UNITED STATES
NUCLEAR REGULATORY COMMISSION
WASHINGTON, D. C. 20555

FACILITY: Peach Bottom Atomic Power Station Units Nos. 2 and 3

SUMMARY OF MEETING HELD ON NOVEMBER 27, 1979

PEACH BOTTOM UNITS 2 & 3
OFFSITE SUPPLIES TO
EMERGENCY BUSES

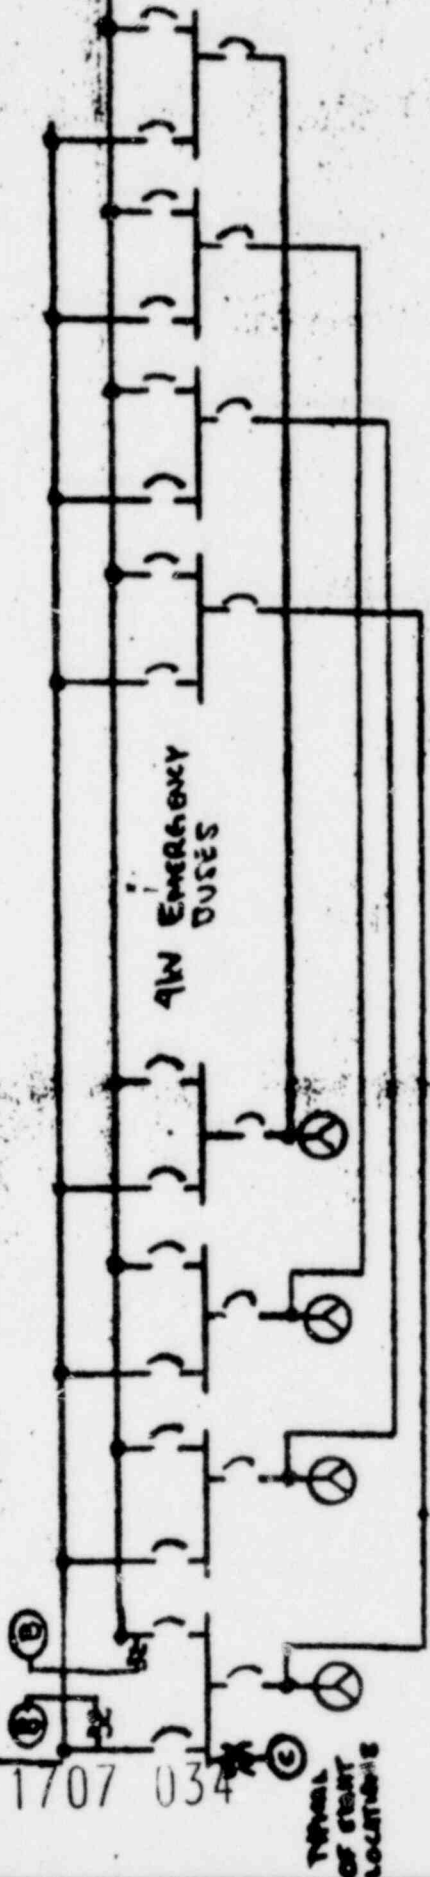
The proposed design is illustrated in Enclosure 1. The staff indicated that conceptually, the design appears to satisfy the staff's requirements. As indicated in NRC letter to PECO, dated October 30, 1979, the licensee should amend his previous submittal. The submittal should also provide a planned schedule for implementing the modification.
